STAFF RECOMMENDATION
1508 Lillian Street
February 15, 2017

Application: New construction—detached accessory dwelling unit; Setback determination

Description of Project: Application is to construct a detached accessory dwelling unit (DADU) at the rear of the lot. The structure requires a rear setback determination from twenty feet (20') to eight feet (8').

ELEVATIONS		H2
Date	1/25/17	
Drawn by	J. Feller	Scale As indicated

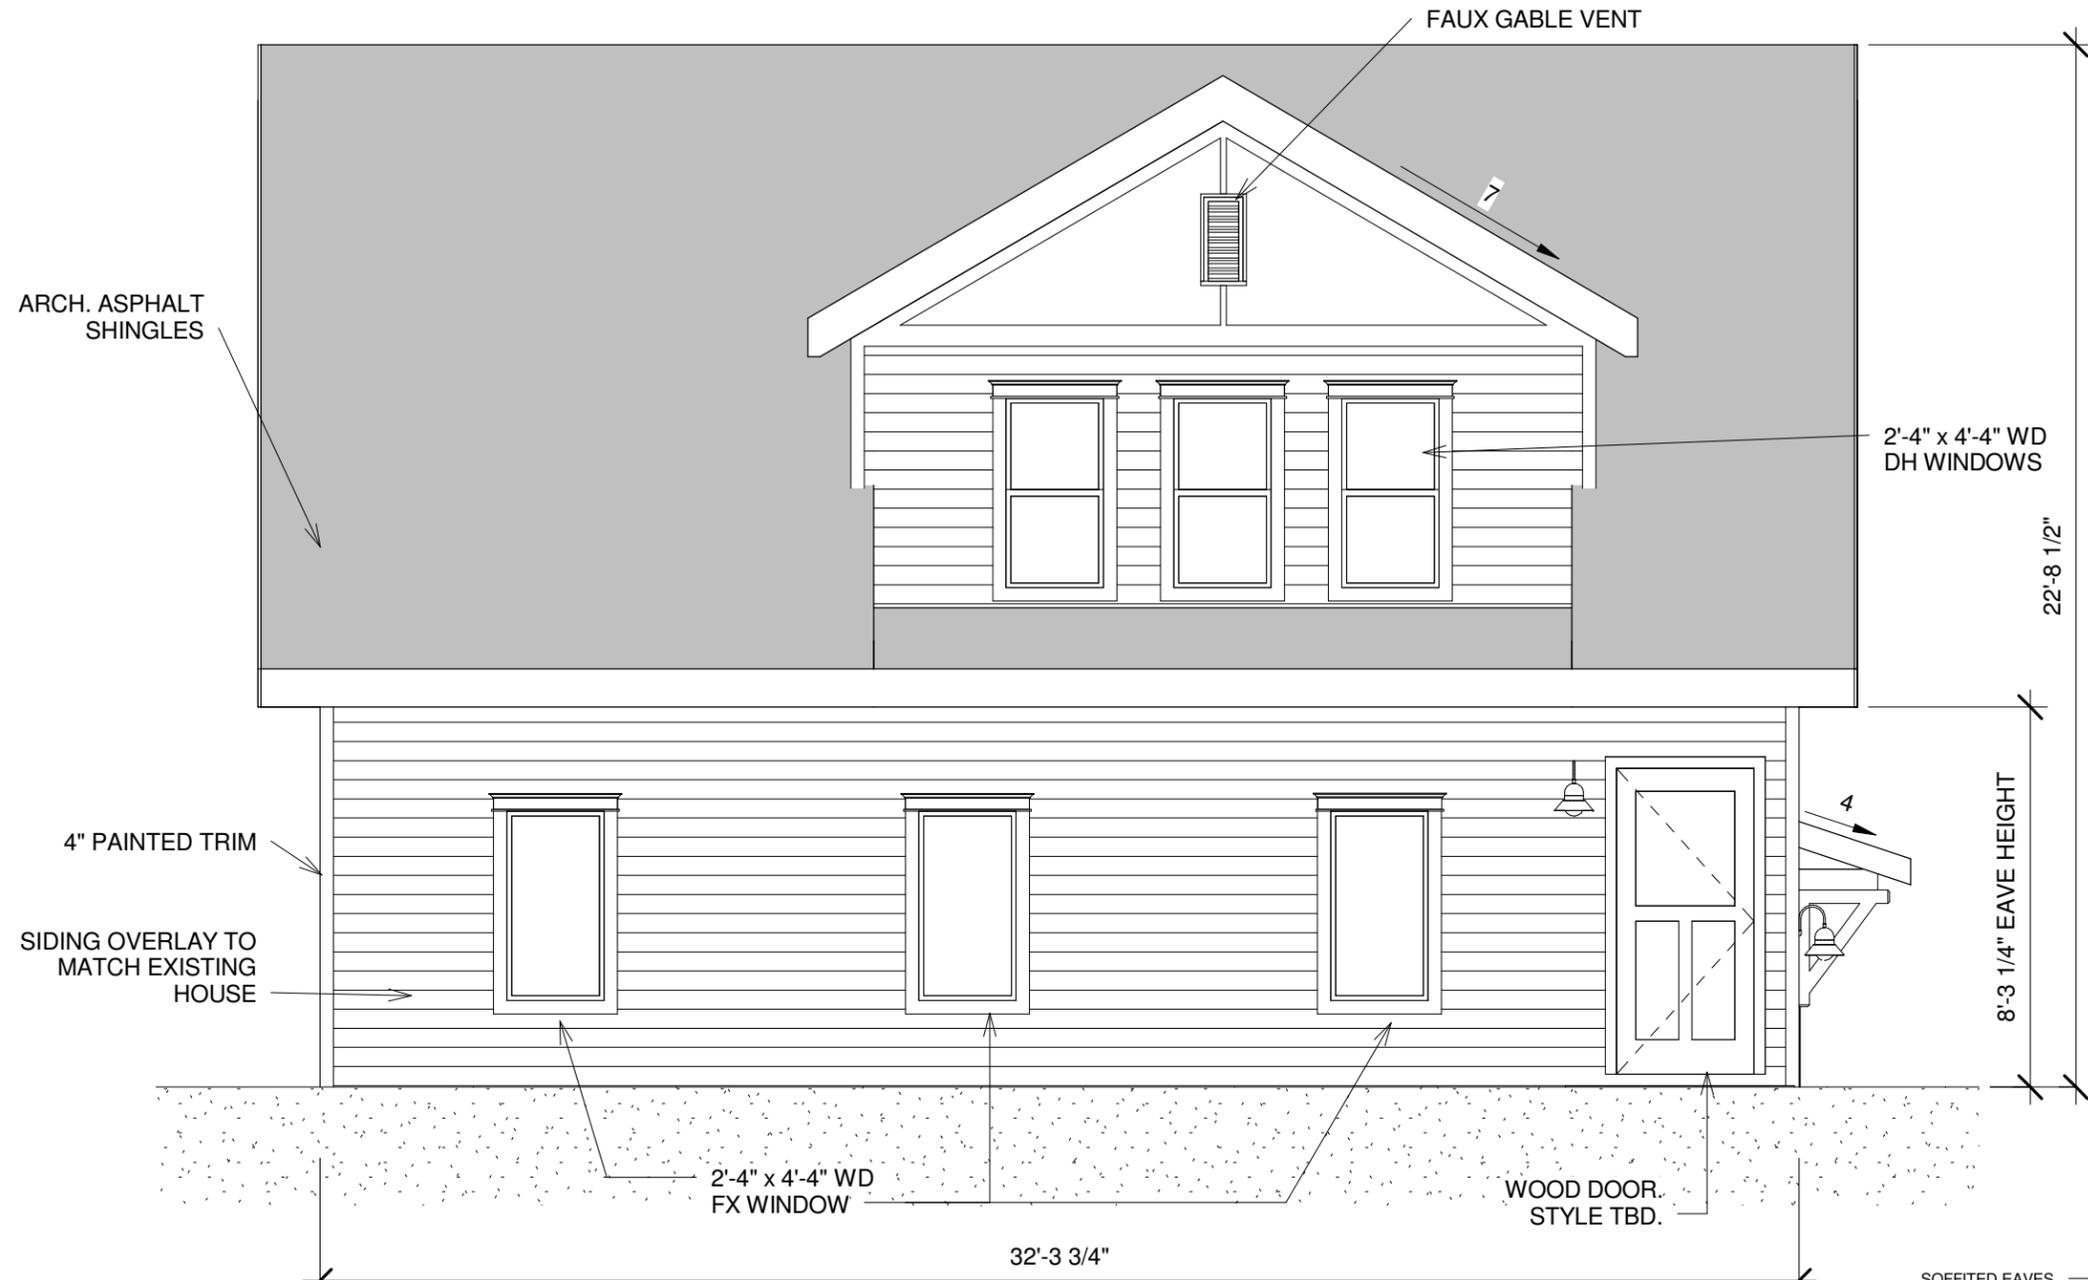
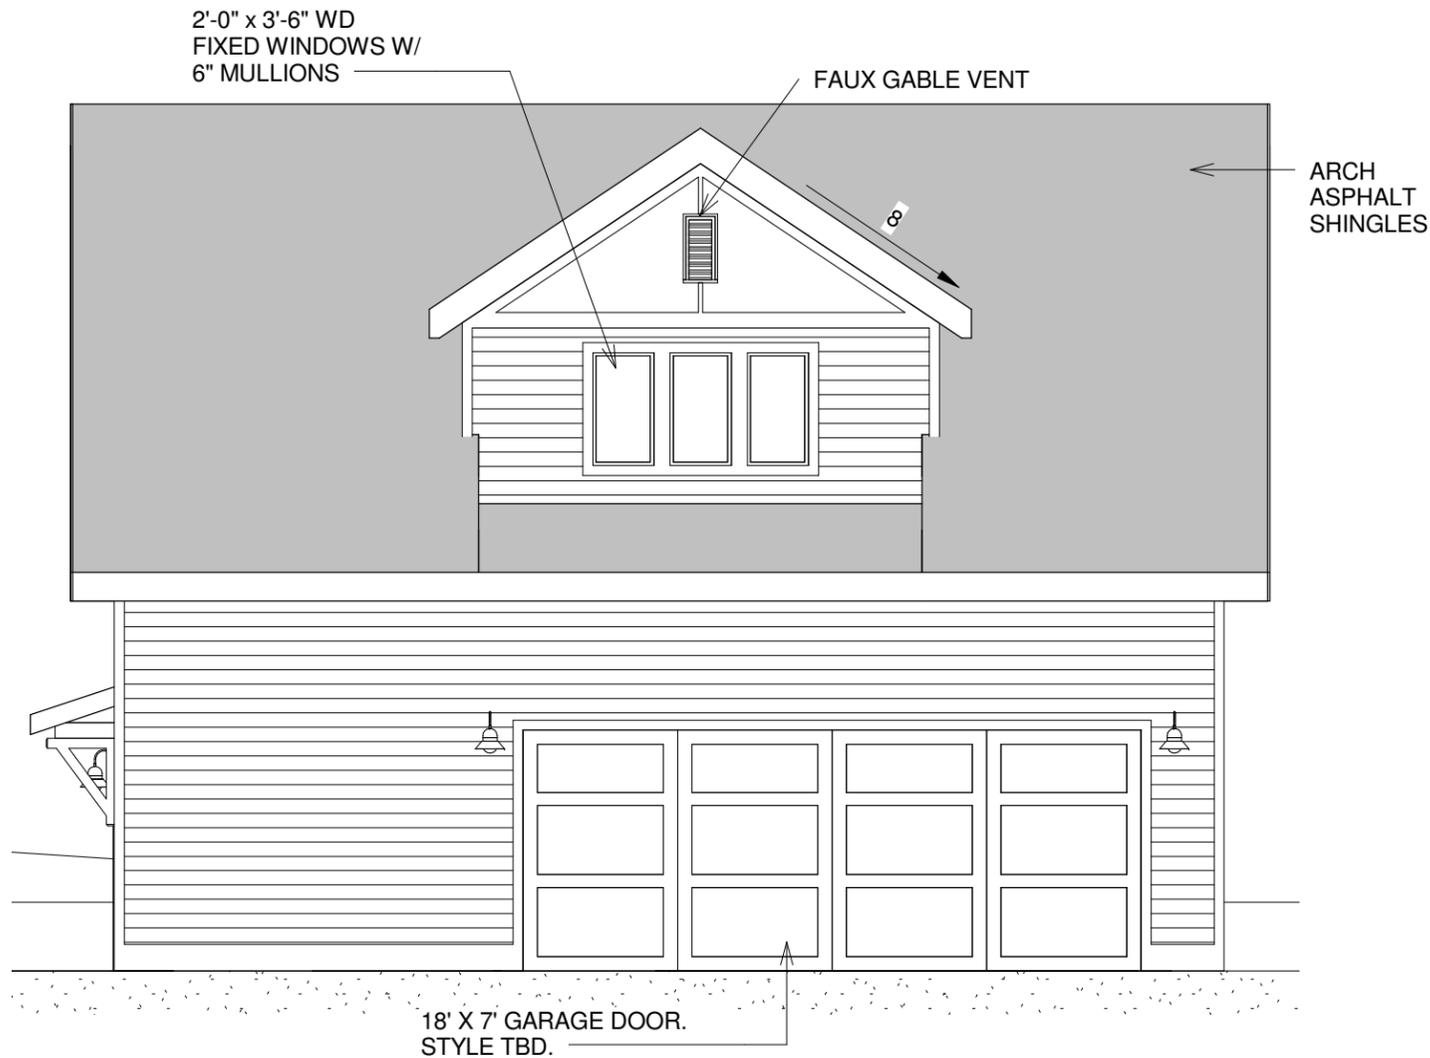
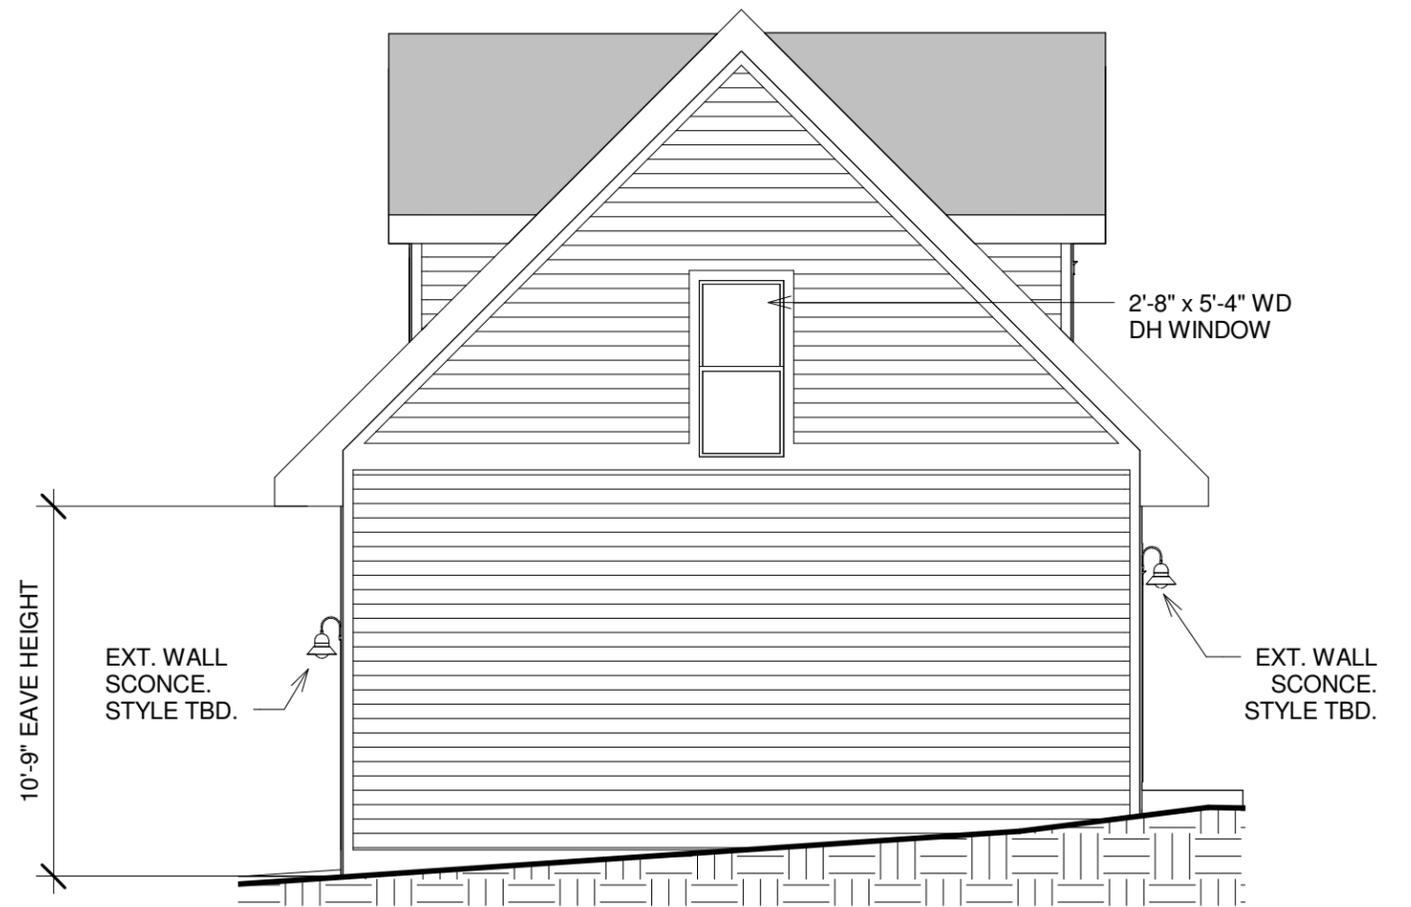
Existing conditions (height of historic portion of the home to be measured from finished floor)	Potential maximums (heights to be measured from grade)	Proposed (should be the same or less than the lesser number to the right)
Ridge Height	26.6'	25'	22'9"
Eave Height	14.5'	10'	8'3"

Lot is less than 10,000 square feet	50% of first floor area of principle structure	Proposed footprint
Maximum Square Footage	750 sq. ft.	948 sq. ft.	744 sq. ft.

Staff finds that the proposed DADU meets Section II.B.8 of the design guidelines and 17.16.30.G. 7 of the ordinance.

1 Site Plan - Historic
1/16" = 1'-0"

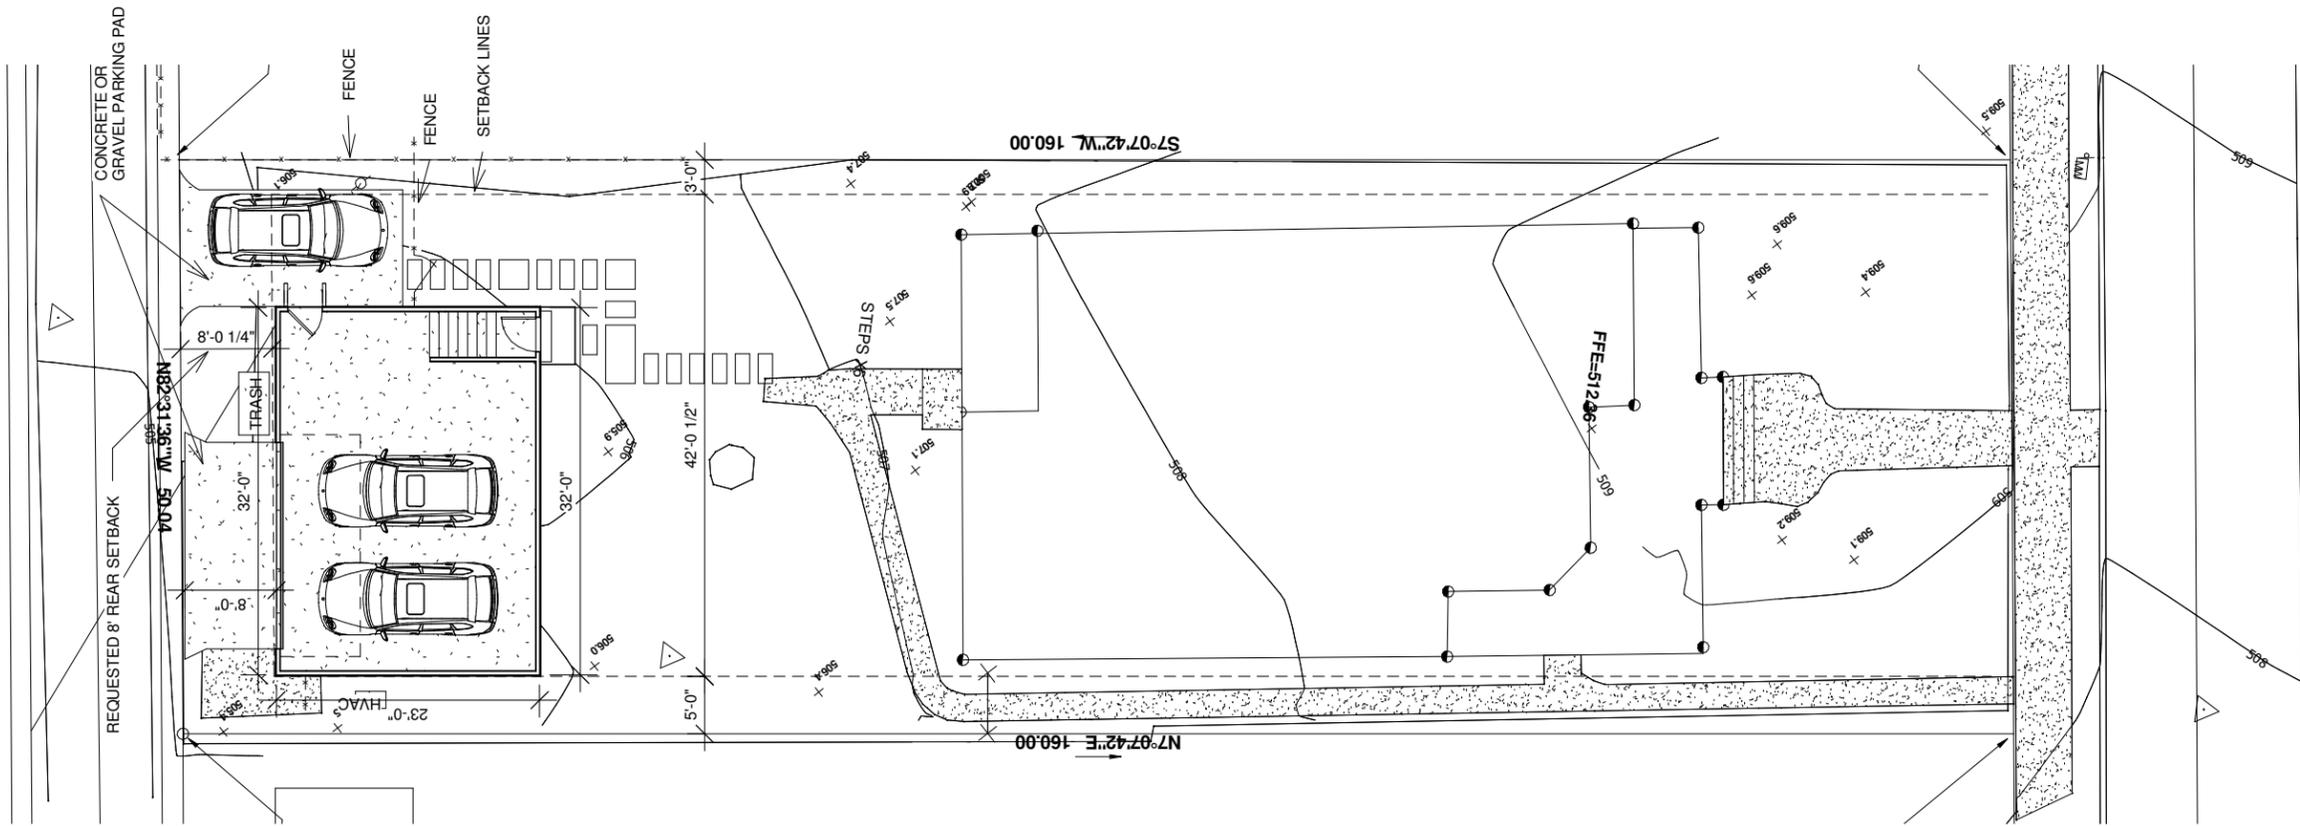
MINIMUM	PROPOSED
Space between principal building and DADU/Garage	20'	37'
Rear setback	20'	8' *
L side setback**	5'	5'
R side setback**	5'	13'
How is the building accessed?	From the alley or existing curb cut	Via Alley

*The new outbuilding does require a rear setback determination. For outbuildings larger than seven hundred square feet (700 sq. ft.), base zoning requires a twenty foot (20') rear setback. The applicant is proposing an eight foot (8') rear setback. Staff finds the proposed rear setback determination to be appropriate because historically, outbuildings were often located close to the rear property line. An eight foot (8') rear setback is more historically appropriate than a twenty foot (20') rear setback. In addition, placing the outbuilding closer to the alley allows for more separation between the primary structure and the outbuilding, which is appropriate.

Staff finds that the proposed DADU meets Sections II.B.3. and II.B.8. of the design guidelines and 17.16.030.G. 4 of the ordinance.
